Product Change Notice (PCN)

Subject: Assembly factory and front-end process change for Shunt Regulator IC (SOP-8)

Publication Date: 3/11/2024

<Form>

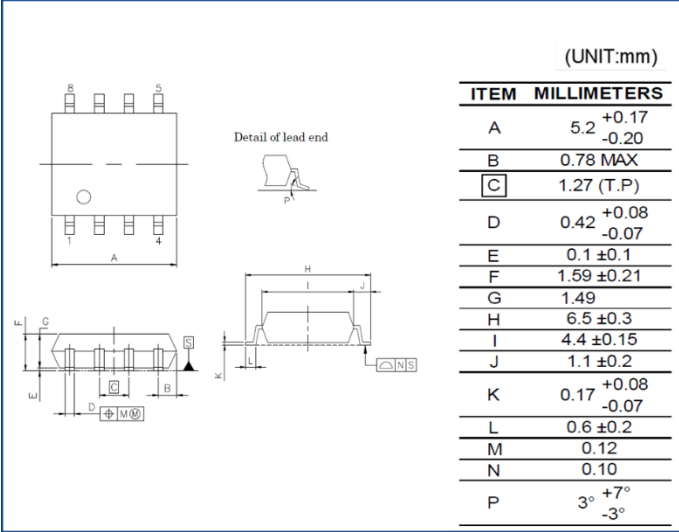
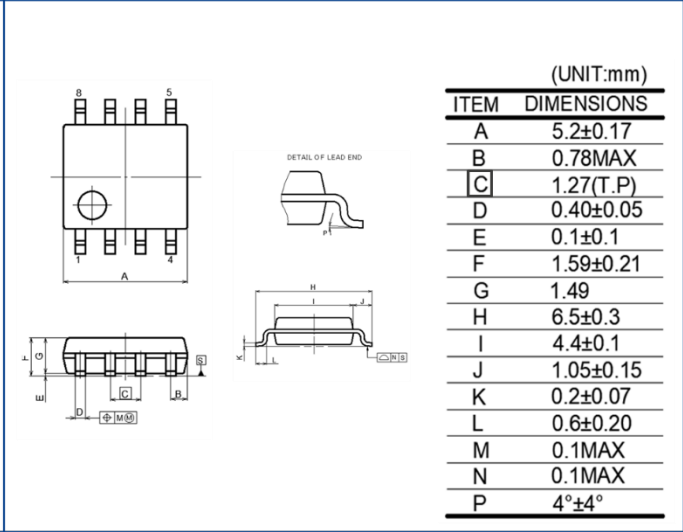
There are some differences in dimensions in the outline drawing, but the recommended foot pattern is not change.

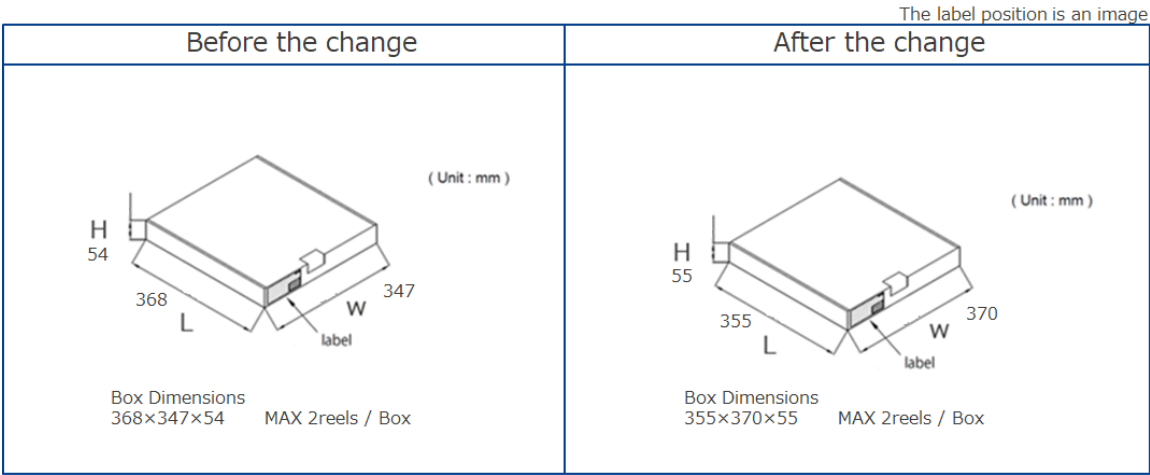
The size of the tape product packaging box changes as shown below.
This is the standard specification that have a proven track record in mass production.

Before (L×W×H)	After (L×W×H)
368×347×54 (mm)	355×370×55 (mm)

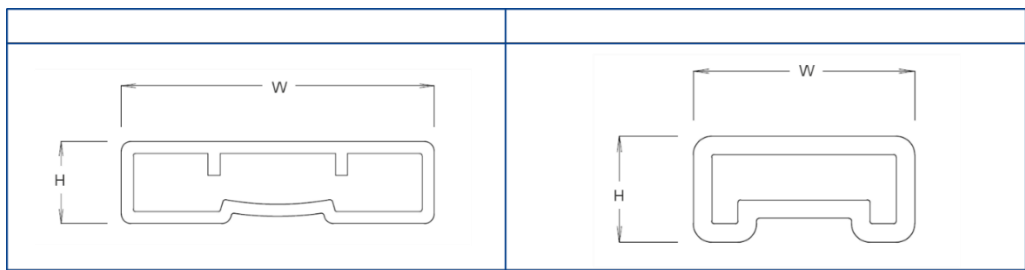
The size of the tube changes as shown below.
This is the open products that have a proven track record in mass production.

Before(L×W×H), Number of packages	After(L×W×H) , Number of packages
530×13×3.4 (mm),Max100 pcs	507~509×8.4×4.0 (mm) ,Max90 pcs

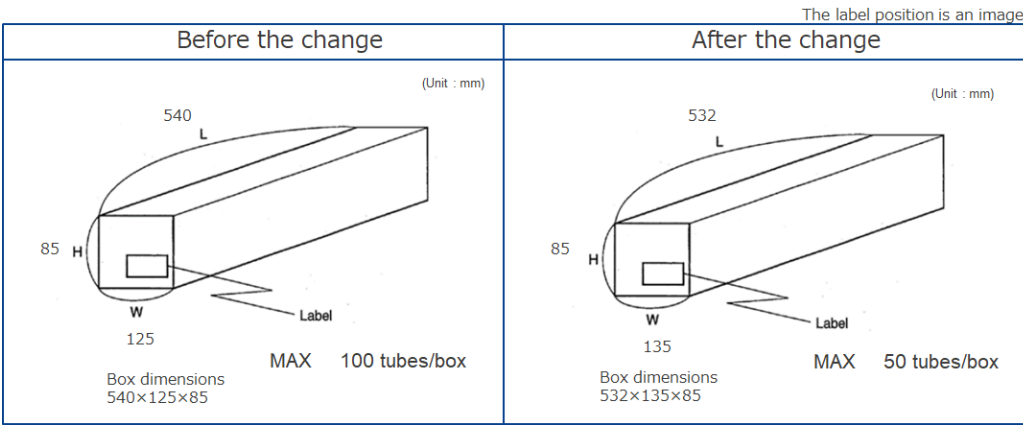
The size of the tube product packaging box changes as shown below.
 This is the standard specifications that have a proven track record in mass production

Before (L×W×H)	After (L×W×H)
540×125×85 (mm)	532×135×85 (mm)

Product identification

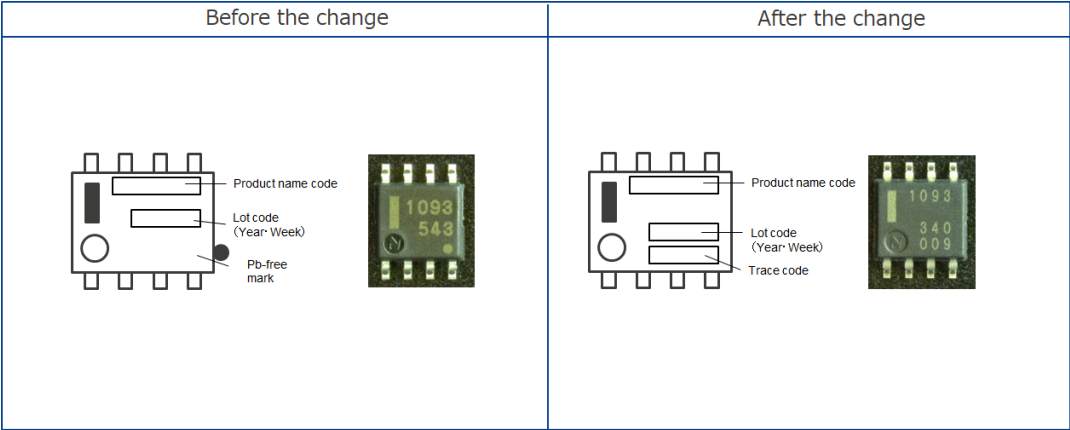
The appearance (Font, Delete Pb-free mark, Add the trace code) of the Mark/ Package Outline of products is different, but Product name code/ Lot code of Mark/Package Outline information is the same.

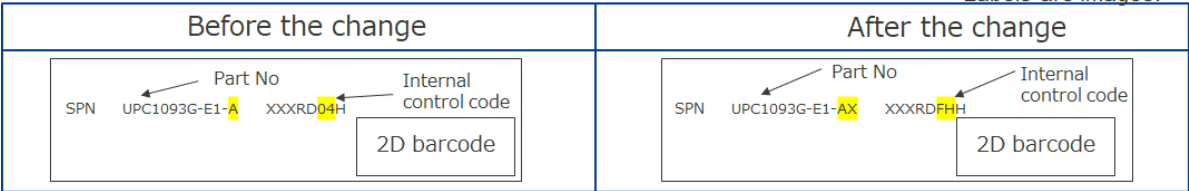
Production sites can be identified by the Labels (Reels, interior boxes).

Item	Before		After
End number of Part No	: -A	→	-AX
Internal control code	: 04	→	FH
